RE: Lot 12 Block 1 Volcano Cliffs Unit 22 SAD 228
8000 Alto Rey Ct. NW
Grading and Drainage Plan
Engineers Stamp Date: 10/19/2020 (D10D003N12)
CO Certification Date: 3/11/2021

Based upon the information provided in your submittal received 3/22/2021, this plan cannot be approved for Building Permit until the following comments are addressed.

SHEET TITLE: GRADING AND DRAINAGE PLAN

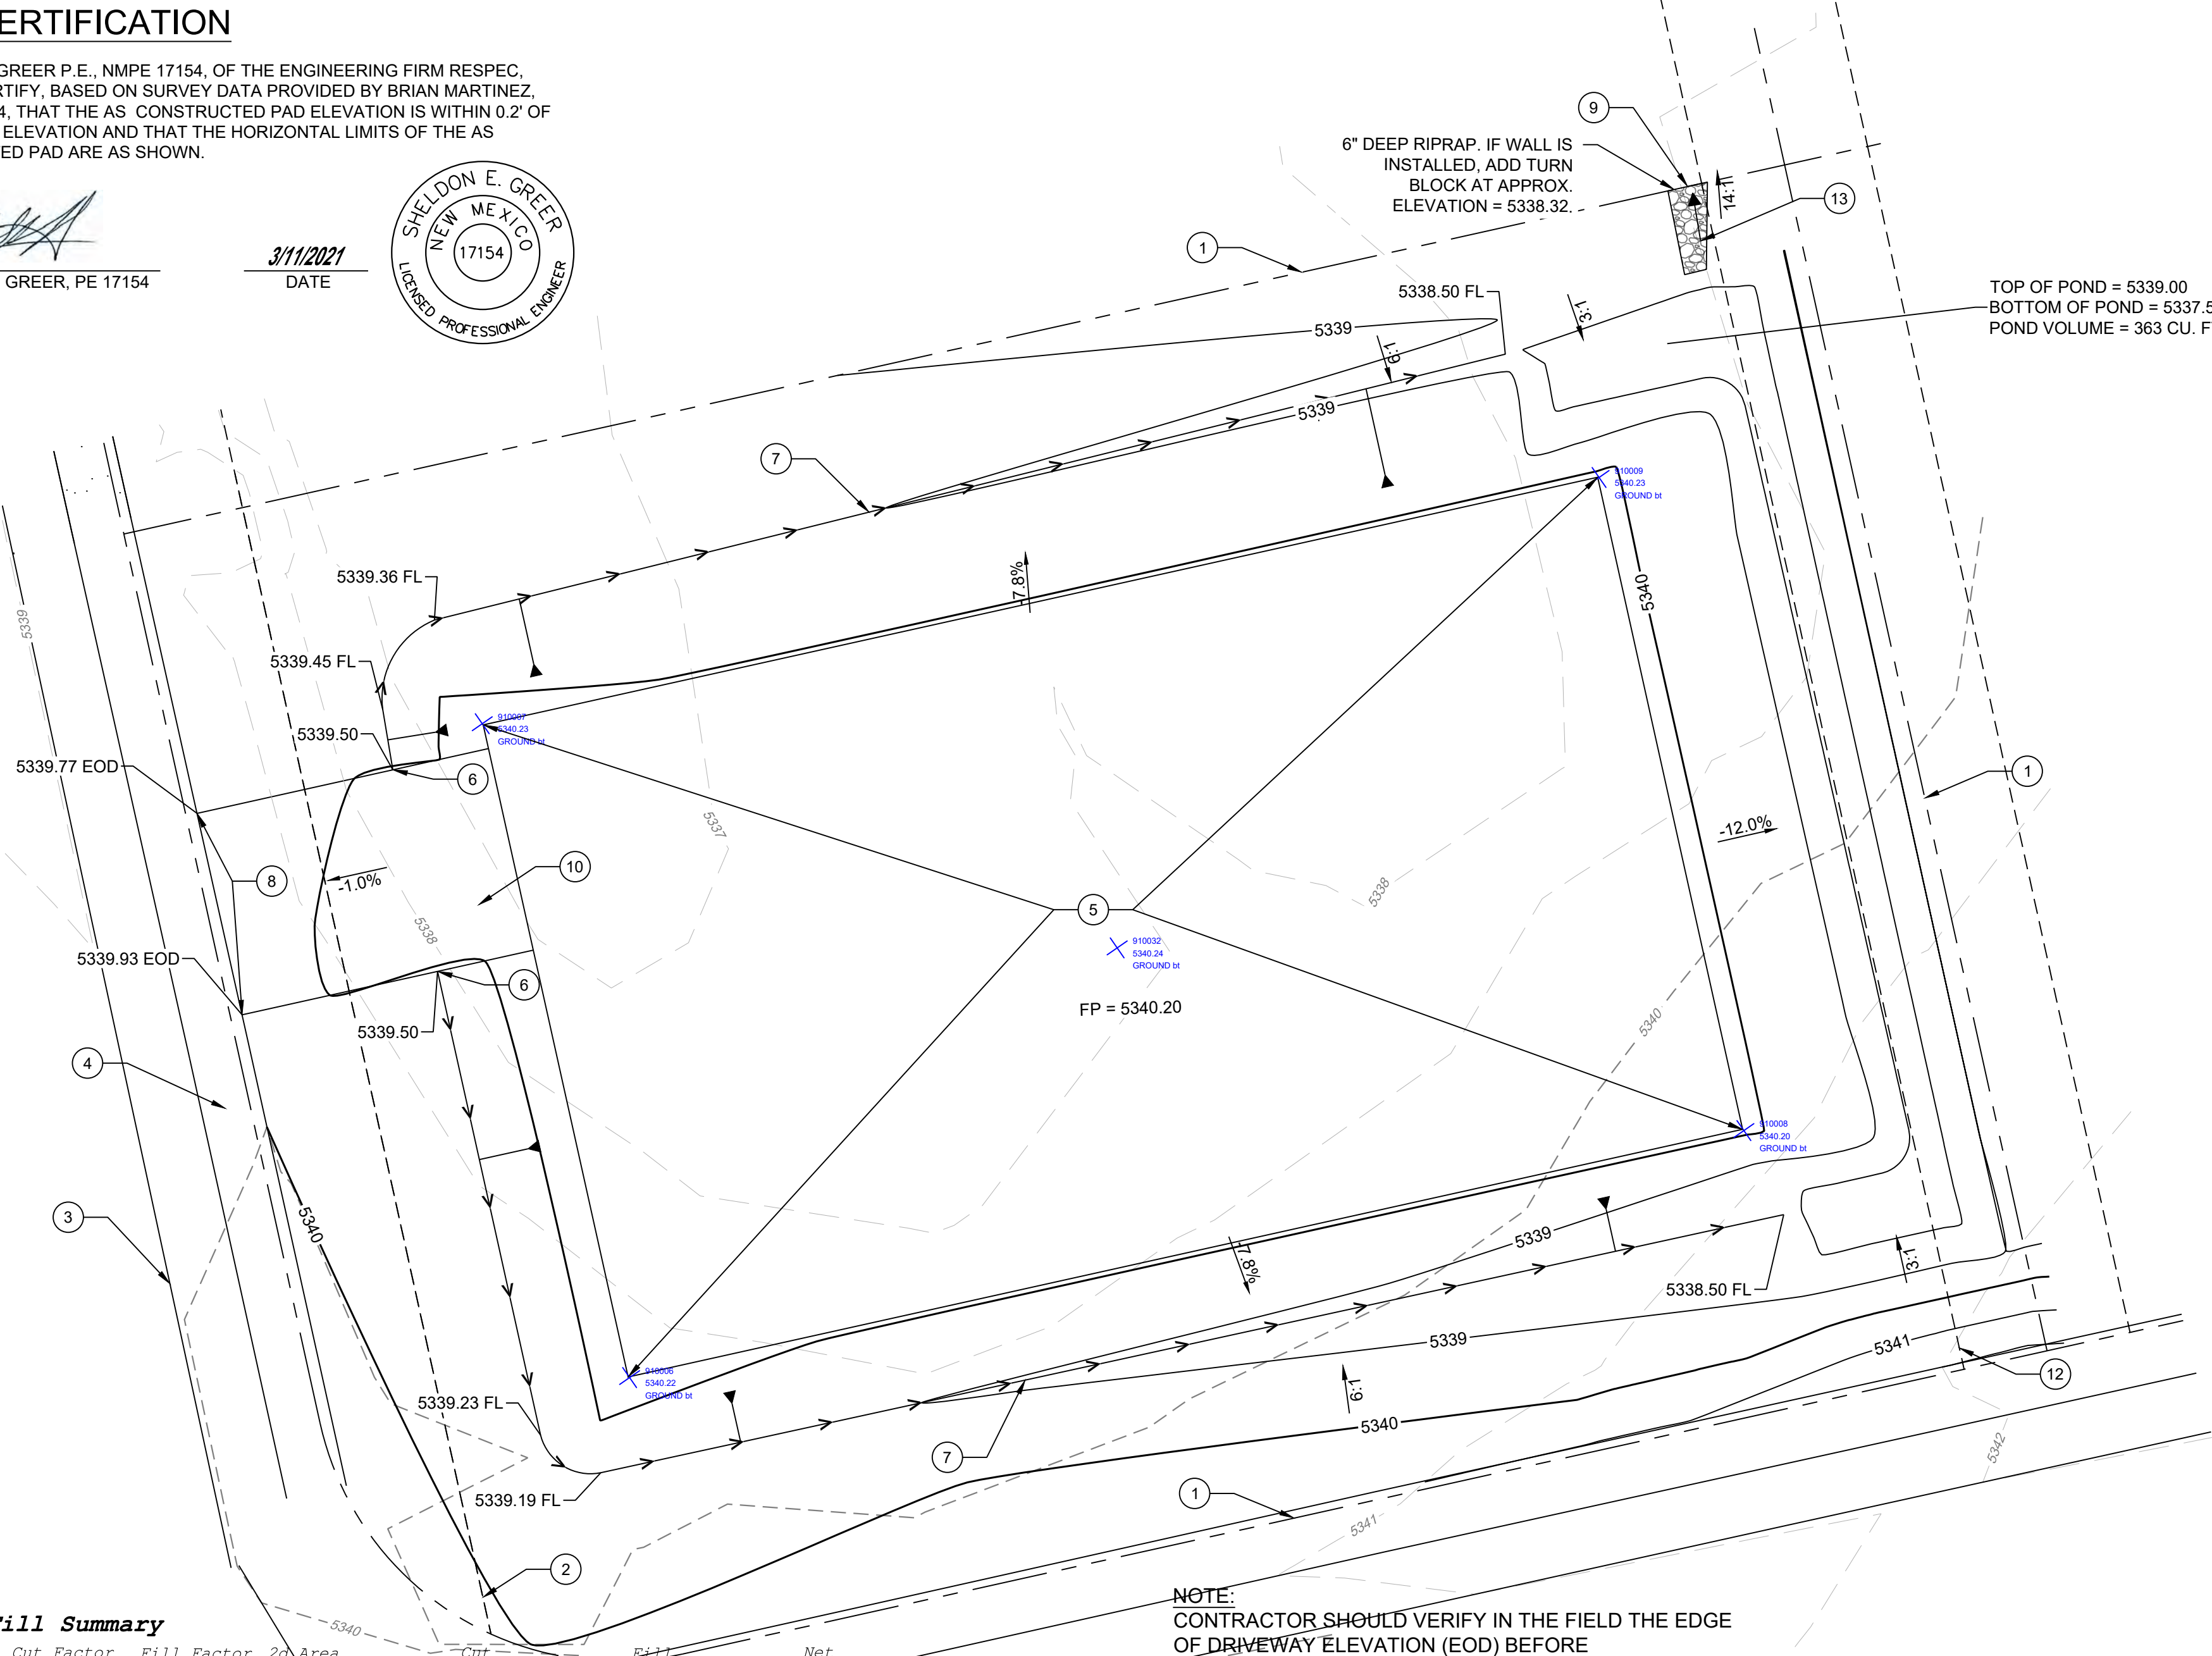
- Lot did not have an address, provide address
- Have all dirt ramps removed from the streets. Crusher fines or lumber are to be used for driving over a curb.
